**Subject:** RE: 37 West Lenox Street, Chevy Chase, MD

We are the residents and owners of the property located immediately to the East of 37 West Lenox Street. We understand that you are considering a preliminary proposal for a restructuring and addition to 37 West Lenox Street. The Commission Staff has provided us with its Staff Report to the Commission. Leading up to this letter we have had some conversations with our neighbors-the owners of 37 West Lenox - as to their plans but the drawings attached to the Commission Staff Report suggest that there have been changes from what we previously discussed. This morning , we were showed by the owners yet another 'plan' for this restructuring and the additions. Our comments are directed at the plans as they were reflected in the Staff Report dated 8/9/06 BUT we can confirm that the plan we saw today only reaffirms our objections as stated below.

**POWELL RESIDENCE**

37 WEST LENOX STREET CHEVY CHASE, MD 20815

GRADING AND LAYOUT

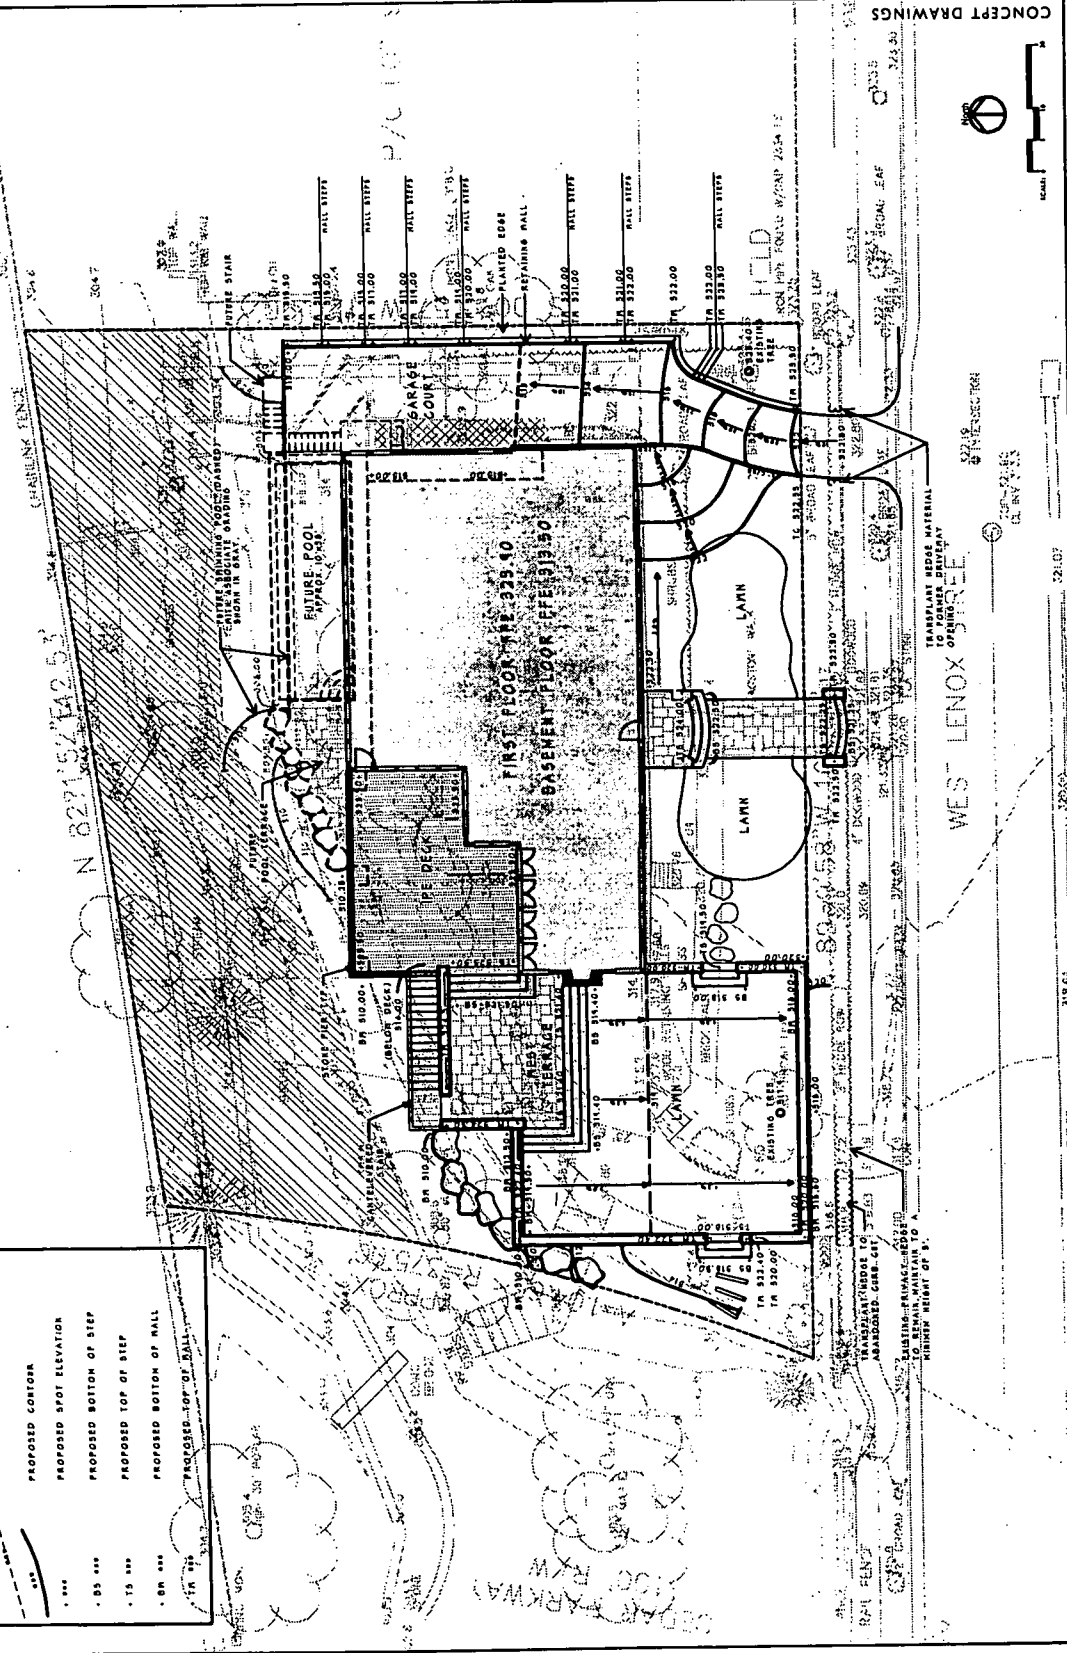
Could I ask you please to look at the overall site map so that you get a good view of how the proposed curb cut is directly opposite Magnolia Parkway.

Our principal concern is with the planned relocation of the driveway to the East side of the house ( the side closest to us ) and the regrading and construction of a retaining wall to accommodate this driveway relocation.

2/ To construct the retaining wall and driveway will a) require the elimination of at least one major/mature tree which is located on our property and potentially require the

elimination of another major/mature tree at the front of the #37 property to accommodate the driveway and the regrading and b) from my own recent experience with retaining walls will cause serious damage to the mature plantings - shrubs and trees along the West side of our home (and the East side of # 37).

4/ To create enough space to be able to turn into and out of the garage from the driveway the actual width of the driveway at its lowest point ( my comments on this are bred from my own shared driveway experience on the other side of my home ) will necessarily be wider and closer to our property ( we were told today it would be 20 feet ) compounding the effects discussed above. In this regard, I call your attention to how long the driveway is from street to the turn into the garage. From the drawings we were shown today it appears to go further into the backyard than other similar driveways in the area thereby dragging the negative affects further into our back yard.

6/ The proposed curb cut - 20' wide at the street is directly opposite Magnolia Parkway which intersects Lenox Street at almost a right angle opposite 37 West Lenox. The effects of moving the curb cut to the proposed location are a) to compound further the deleterious effect of the alteration of the street scape in the neighborhood ( making the drive visible up Magnolia Parkway and b) to create an unnecessary safety issue at the new ' junction' of the driveway and Magnolia and Lenox Streets ( with the mature plantings, the on street parking ( in large measure due to the shared driveway between our home and the next one on the East side) and the vehicular traffic, it is quite obvious why the original designer planned the driveway at #37 to be on the West Side of the lot).

I will ensure that the Commission notices the location of the curbcut in relationship to Magnolia Parkway.
